**TOWN OF OCEAN RIDGE
PLANNING & ZONING REGULAR MEETING
AGENDA**

To:	Planning & Zoning Board Members
From:	Corey O’Gorman, Town Planner
Meeting Date:	September 16, 2025
Subject:	6470 N Ocean Blvd – Development Plan Review

PLAN REVIEW REPORT
6470 N Ocean
05/20/25
Revision 06/05/2025/Revision 06/19/25

July 24, 2025**To: Kelly Avery, Town Clerk****From: Tara Bamber, PE** **Re: 6470 North Ocean Boulevard
Development Plan Review
Engenuity Group Project No. 00020.10**

A-1

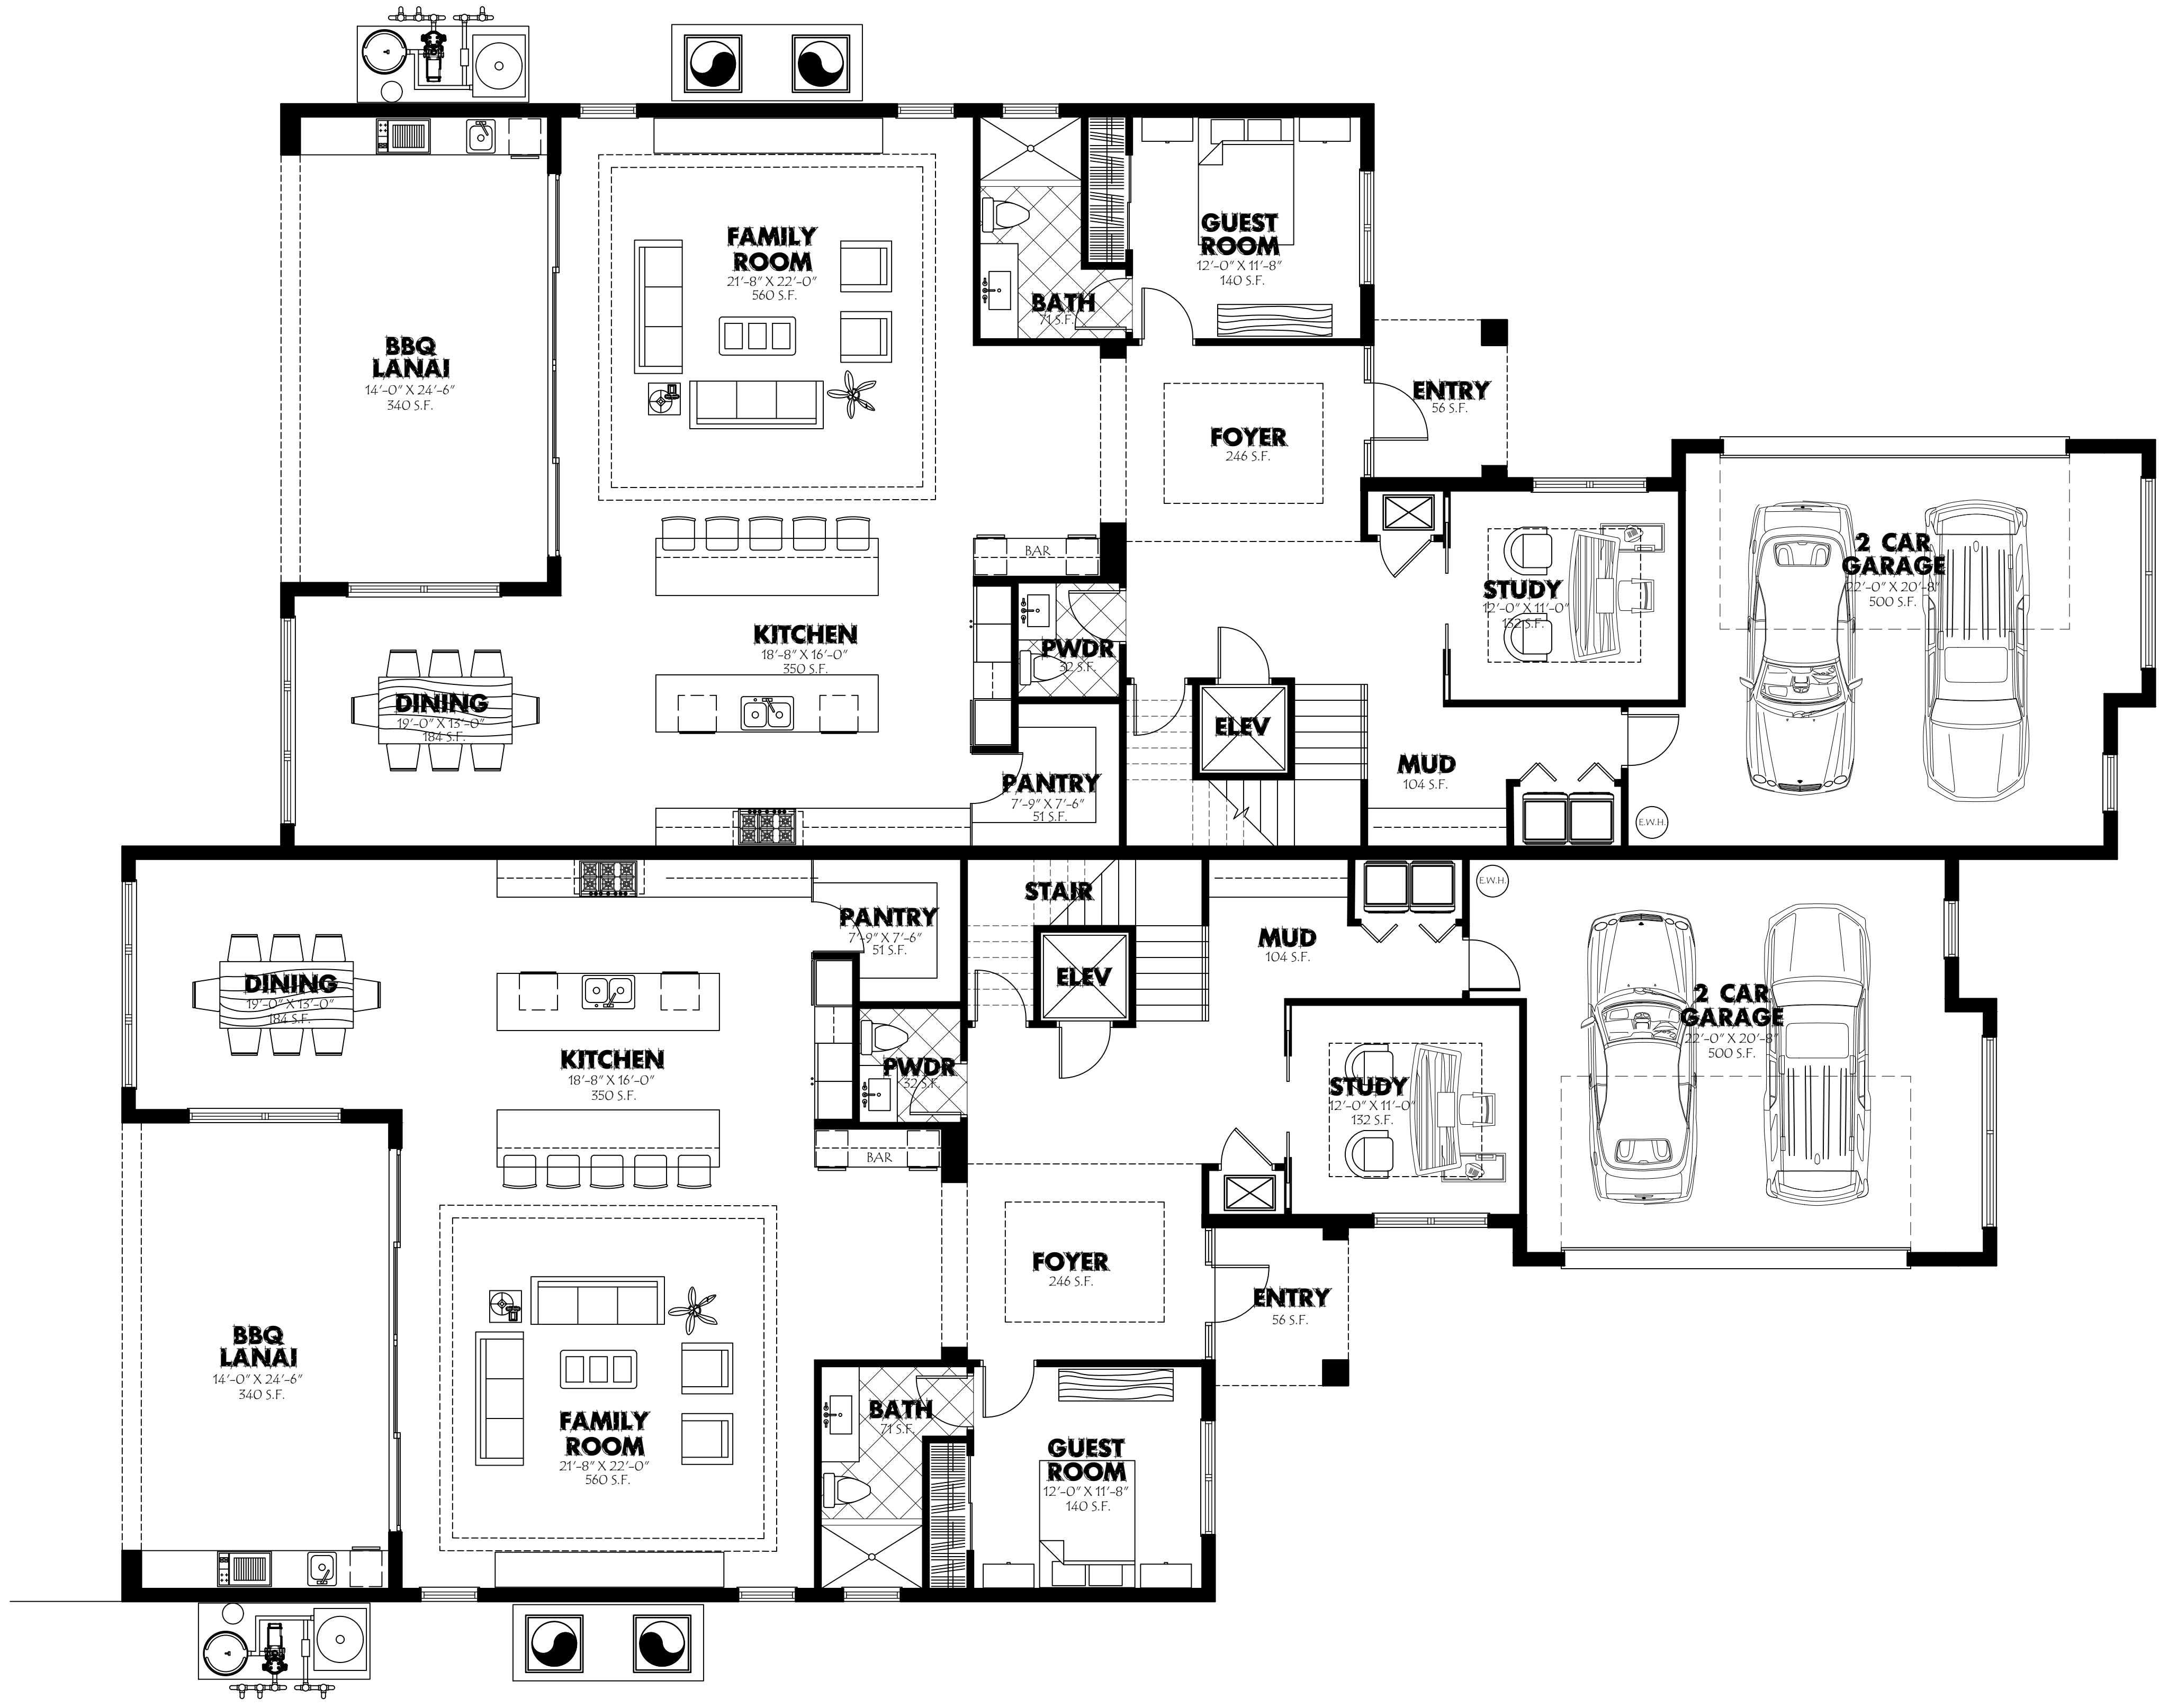
- ~~The site plan Sheet A-1 shows a lot line between the proposed units, and at the pre-application meeting subdividing the units to be sold as fee simple was discussed. Please confirm if this is still the intent. If so, a Unity of Control may be needed to address future improvements to the units, buildings and properties.~~ **As per the comment from the applicant to the Town Clerk, "Yes, the units will be fee simple sales. We will be providing a Unity of Control prior to permit issuance." This comment has been addressed and a condition of approval is that the applicant is required to provide the Unity of Control prior to permit issuance.**

- ~~Please revise the site data tabulations on Sheet A-1 to be consistent with the required data shown on the LDAA checklist, including "required" and "proposed".~~ **Comment addressed.**

Section 64-2(e)(1) ~~**Background:** This Code section required minimum lot width of 100 feet. The data tabulation on sheet A-1 indicates that the lot width is 108.6 feet, but this dimension is not shown on the plan.~~

Comment: Please revise the site plan to show where the 108.6 foot lot width dimension to ensure compliance with minimum lot width.
Comment addressed.
